ENERGY & ENVIRONMENT

Re: Arkansas Division of Environmental Quality Comments
Docket No. EPA-R06-OAR-2021-0801

Arkansas State Implementation Plan Revision: 2015 Ozone National Ambient Air Quality
Standard–Interstate Transport

Figure 1: Historical NOx Emission Data for Honeywell International

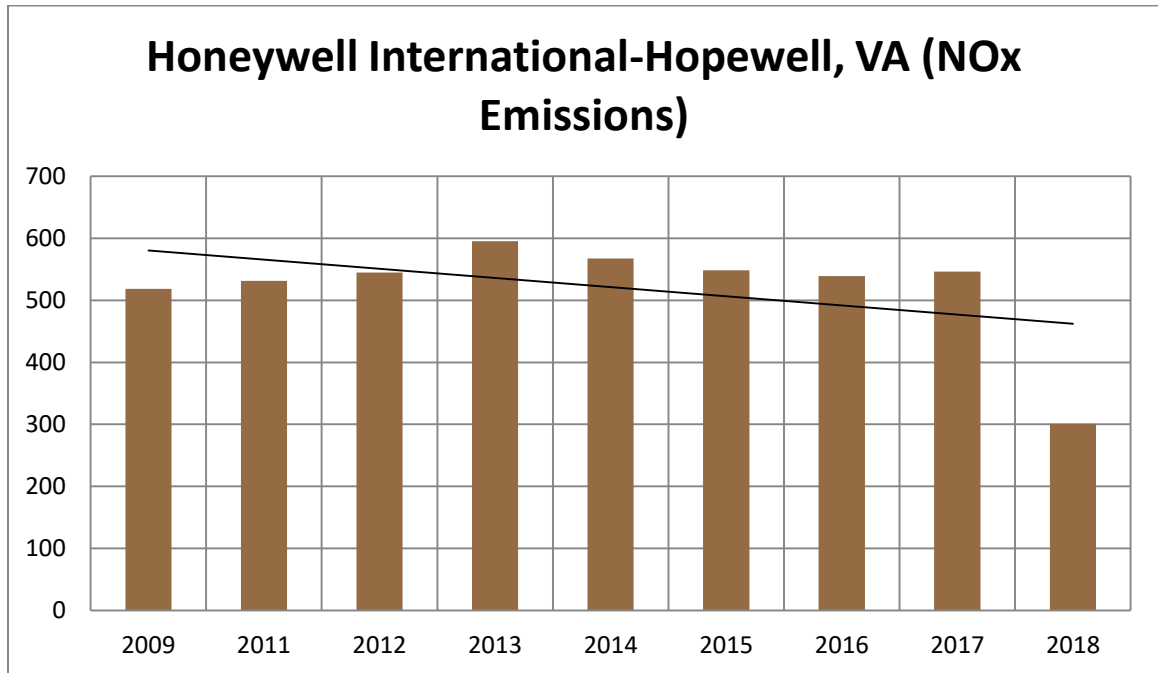
4. The future year projection factor for NOx emissions from "Honeywell International Inc. – Hopewell" (unit# 20375813) in Virginia is 6.79 for 2026 in the 2016v2 platform and was 0.63 for 2028 in 2016v1 platform. DEQ conducted trend analyses to evaluate some future year projection factors and DEQ's analysis for this source does not appear to support a future year projection factor of 6.79 and may support a future year projection factor of 0.62; however, Virginia may have suggested the 6.79 as the appropriate value and, if so, would likely be the best source of this data. DEQ suggests that EPA verify the above example, possibly with Virginia if data was not already provided by Virginia, and other similar examples.

Figure 2: Historical Emissions from John W. Turk Power Plant, AR

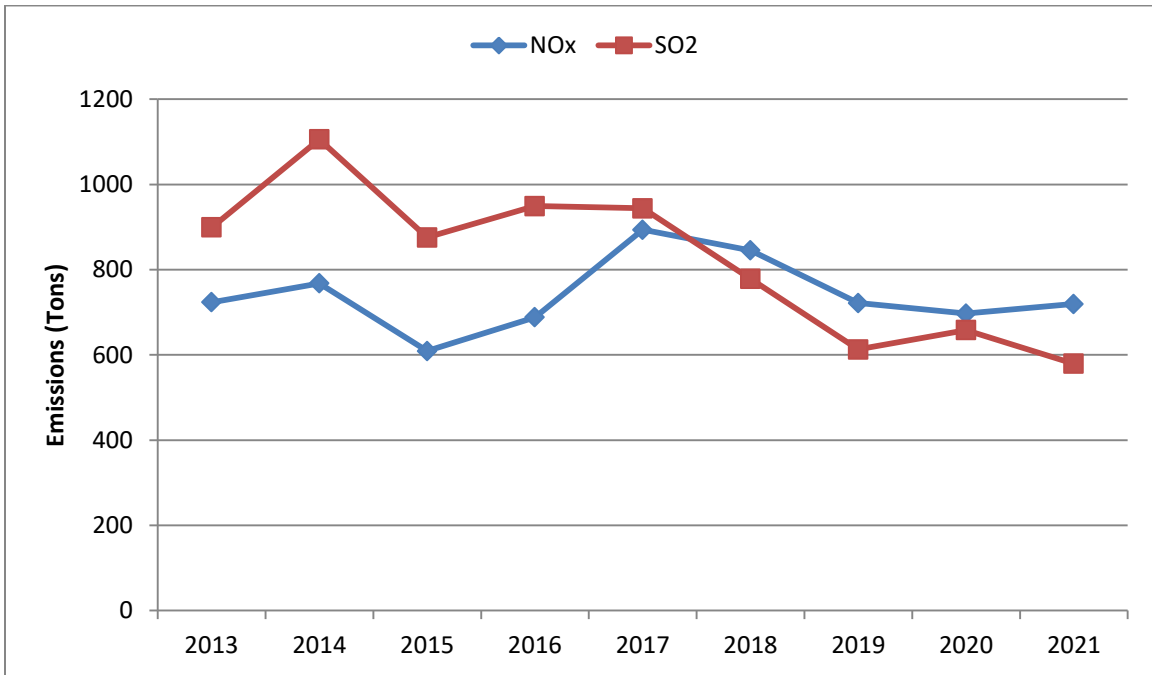
8. IPM did not project 2026 and 2032 ptegu sector emissions for the John W. Turk Power Plant. However, IPM did project 2026 and 2032 ptnonipm sector emissions for this facility of NOx at less than 1 ton and SO₂ at less than 1 ton. Historical NOx and SO₂ emissions for the John W. Turk Power Plant are presented in Figure 2. EPA should include appropriate 2026 and 2032 ptegu sector emissions and verify the 2026 and 2032 ptnonipm sector emissions for the John W. Turk Power Plant.

Figure 3: Historical Emissions from Plum Point Energy Station, AR

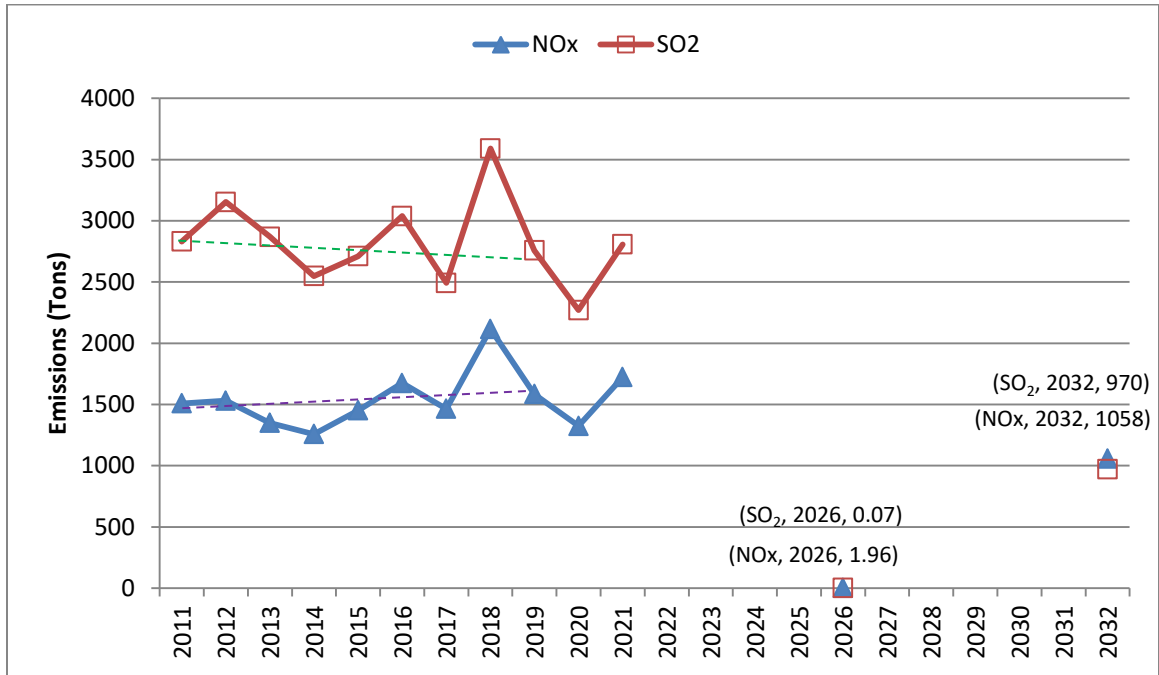
9. IPM did not project 2026 ptegu sector emissions for the Plum Point Energy Station. However, IPM did project 2026 ptnonipm sector for this facility of NO_x at 1.96 tons and SO₂ at 0.07 ton. Historical emissions for the Plum Point Energy Station are presented in Figure 3. In addition, IPM did project 2032 ptegu emissions, although the 2032 ptegu future year projection was a 62% reduction for SO₂ emissions from a 2021 baseline. For the Plum Point Energy Station, EPA should include appropriate 2026 ptegu sector emissions, verify the 2026 ptnonipm sector emissions, and verify the reasonableness of the 2032 ptegu SO₂ emissions.

Figure 4: Historical Emissions from Oswald Generating Station

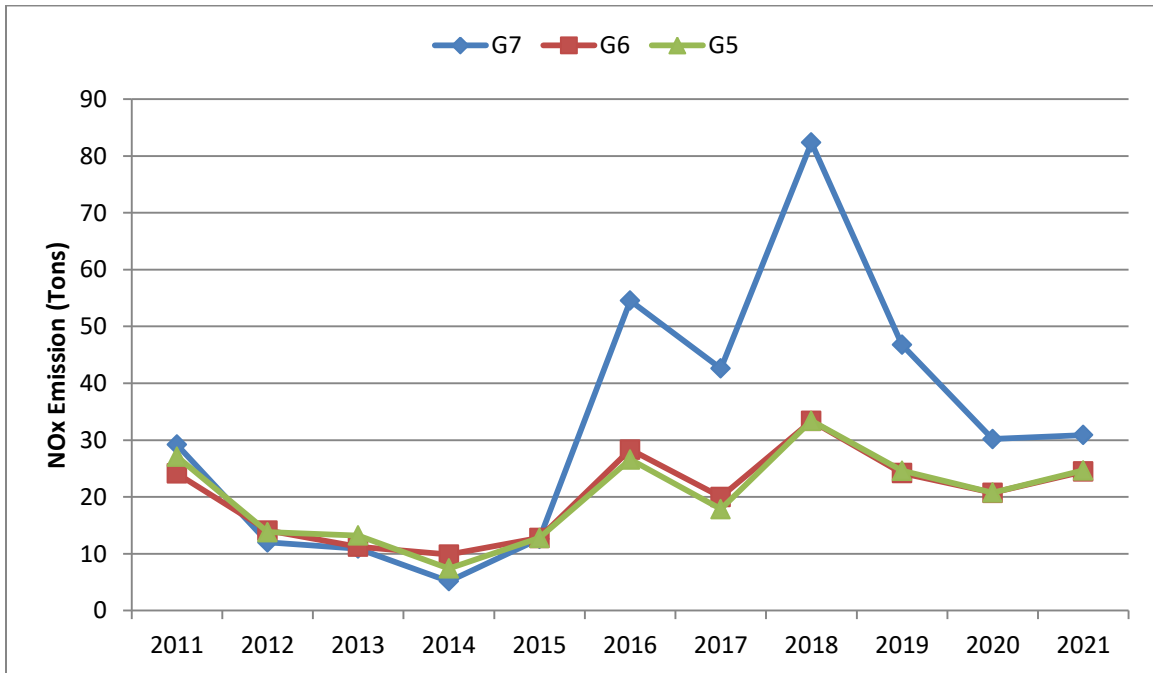
10. IPM 2026 projected NOx emissions from the ARK Elec Co-Op-Oswald Generating Station are Unit G7: 172 tons, Unit G6: 115 tons, and Unit G5: 115 tons. IPM 2032 projected NOx emissions are Unit G7: 160 tons, Unit G6: 107 tons, and Unit G5: 107 tons. Table 1 provides gross load from IPM future year projections and a 5-year average of historical data (2017-2021) for these units. The 2011-2021 historical NOx emissions for these units are provided in Figure 4. EPA should verify the reasonableness of projected 2026 and 2032 NOx emissions for all of this facility’s units and potentially for IPM-projected emissions at other facilities.

Figure 5: Modeled Contributions from All Linked States to Harris County, TX monitor (482010055)

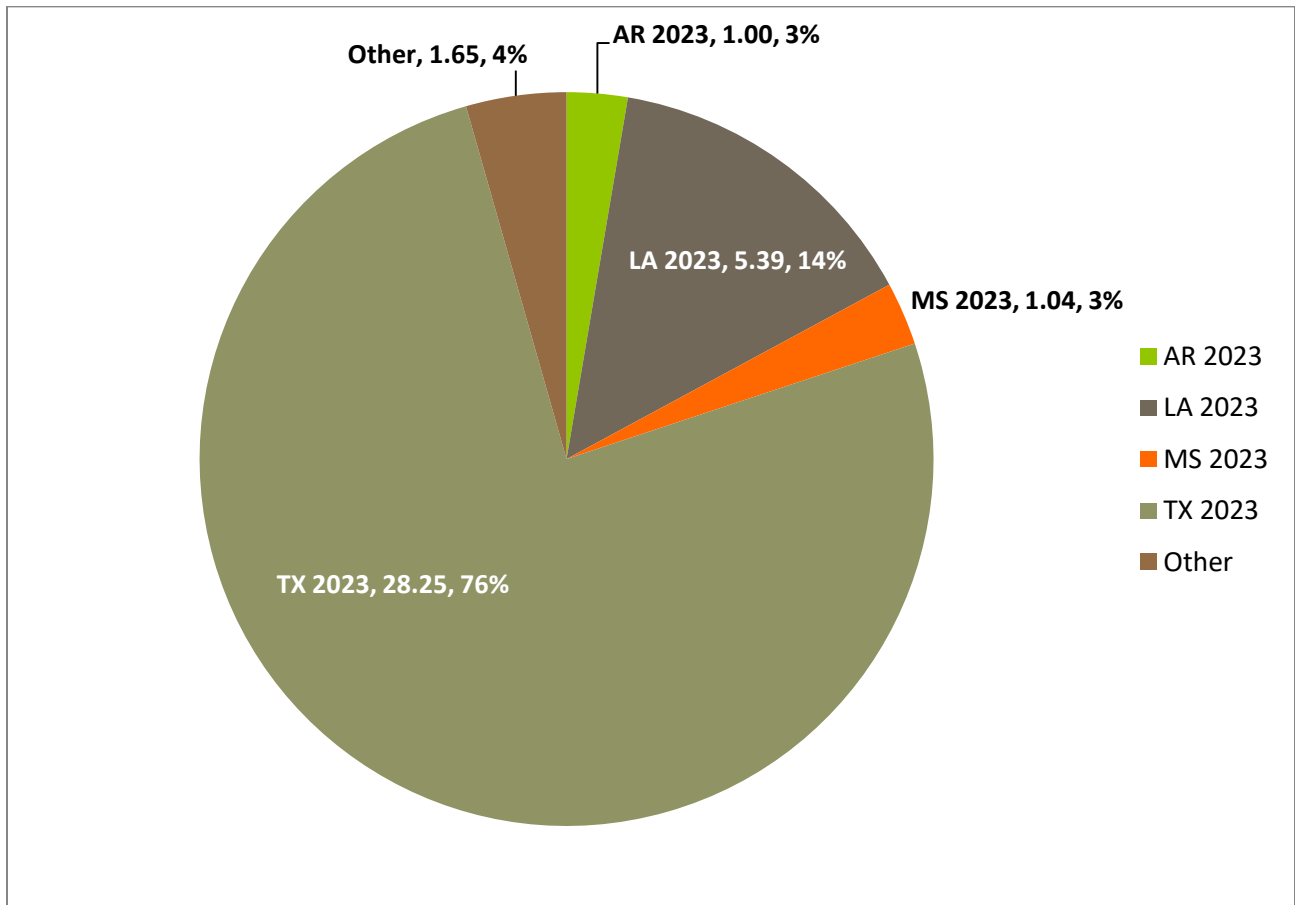
As a snapshot illustration of this point, Arkansas's linked contribution to the Harris County nonattainment monitor is modeled at 1.00 ppb. The modeled contribution from Texas is 28.25 ppb, more than 28 times the contribution from Arkansas, and Louisiana's contribution is 5.39 ppb, more than 5 times the contribution from Arkansas (see Figure 5). When contributions from international, offshore, initial and boundary conditions, fires, and biogenics are included, Arkansas's contribution falls to 1% of total contributions at the Harris County monitor (see Figure 6). Figures 5 and 6 illustrate the relative contributions from all linked states and the relative contributions from all states as well as international, offshore, initial and boundary conditions, fires, and biogenics.
